Supply and Demand Correlation

New Mexico – Gila Basin – Arizona Water Settlement Act

**U.S. Department of the Interior
Bureau of Reclamation
Phoenix Area Office**

Attachment A – Supply and Demand Correlation Comments/Responses

Figure 2.1. – 2005 Water Withdrawals Throughout Study Area

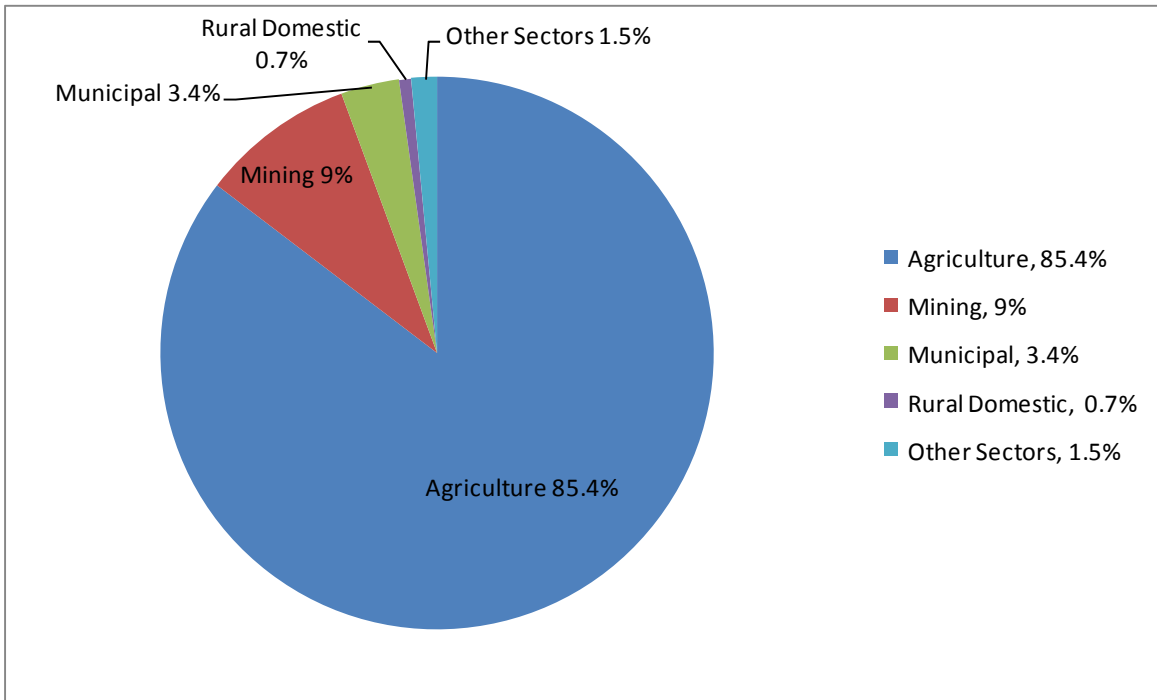
1. **P7, section 2, last par:** *Comment:* Change to Depletion = Diversion – Return.

- 3. P9, section 2.1.2 through section 2.1.5: Comment:** This section apportions water demand by sectors. It would be useful to include a pie chart that allows relative proportions of demand by sector to be easily seen.

Response: Paragraph revised.

Response: A pie-chart has been added.

Figure 3.1. – Map of Southwest New Mexico Planning Area

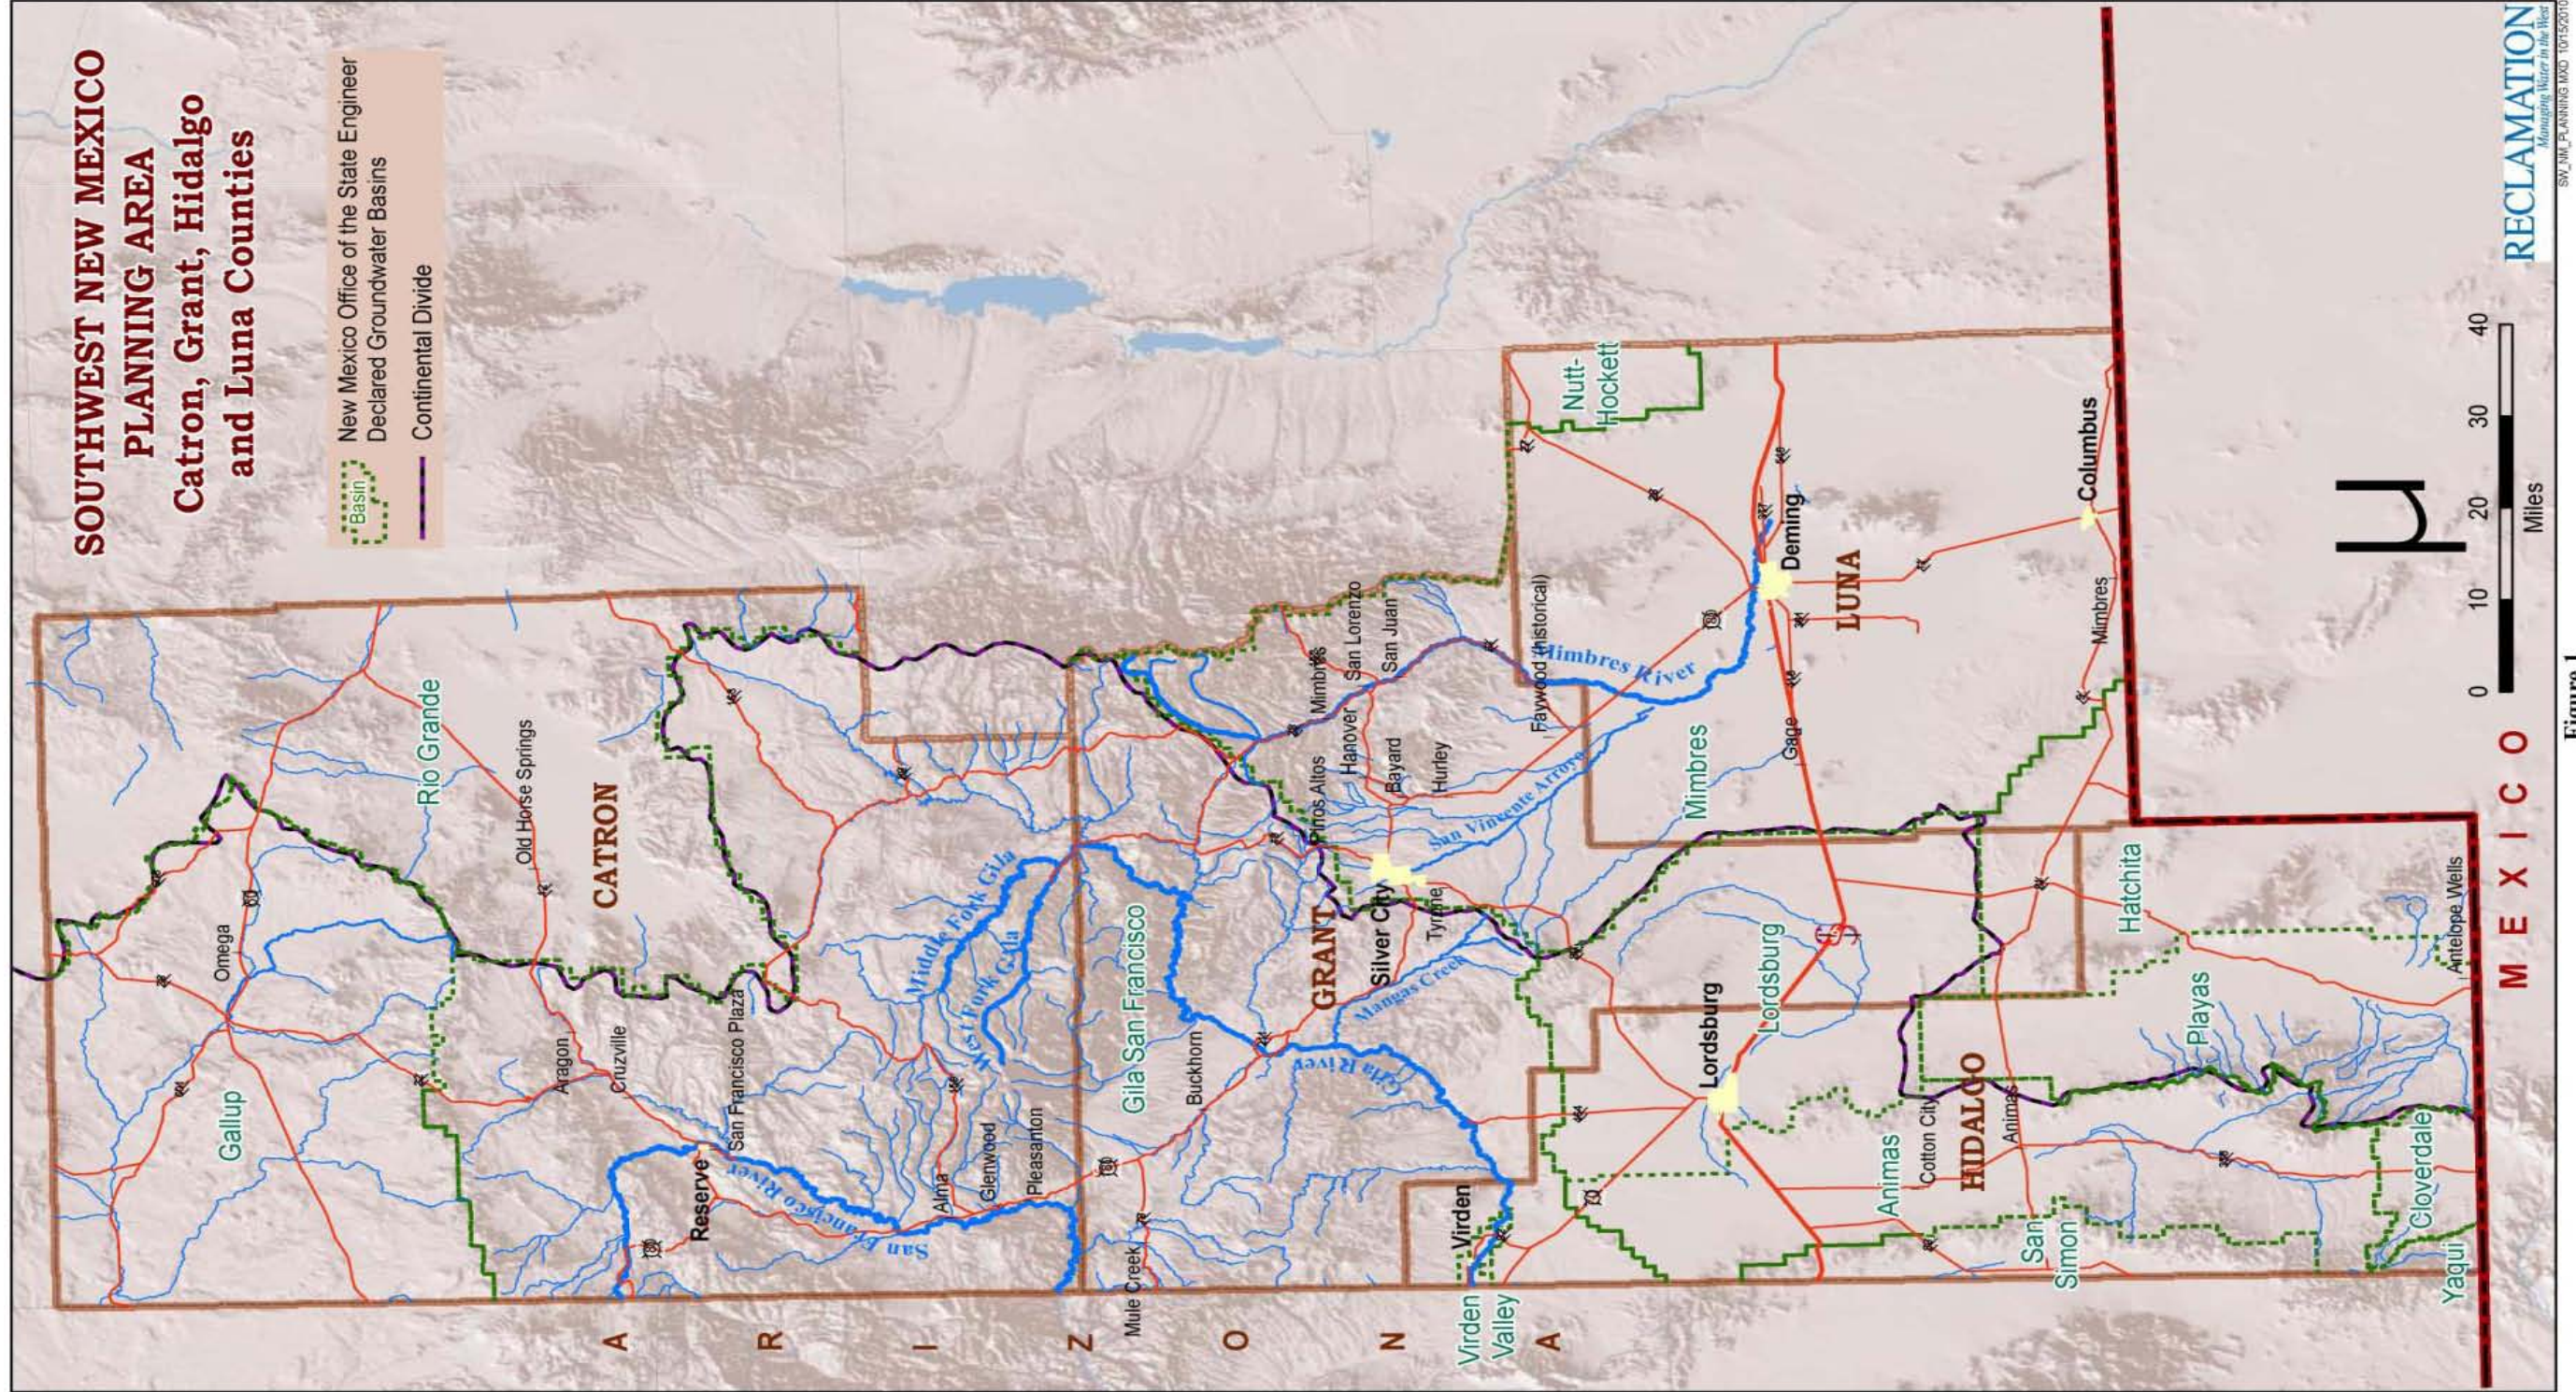
- 3. P4, section 1.2, par 4: *Comment:*** Does SSPA specify where or in different locations?

Response: SSPA did mention recent monitoring of alluvial observation wells installed along four transects across the Gila River (Figure 3.1) in the Gila-Cliff Valley. It is interpreted the statement refers to the four transects (FM-1, FM-2, Bird, and TNC transects; see Fig. 3.1) and intervening seepage investigation measurement areas (see Fig. 3.8) along the Gila River in their two Riparian models, in Reaches 1 and Reach 2. These two model areas occur between Mogollon Creek at Gila River to the north, and below Mangas Creek where it joins the Gila. They were able to characterize gains and losses in reaches between the USGS gage Gila River near Gila (09430500) and the Bird Area, which is located upstream of the Middle Box area.

The text was rewritten to better clarify the location.
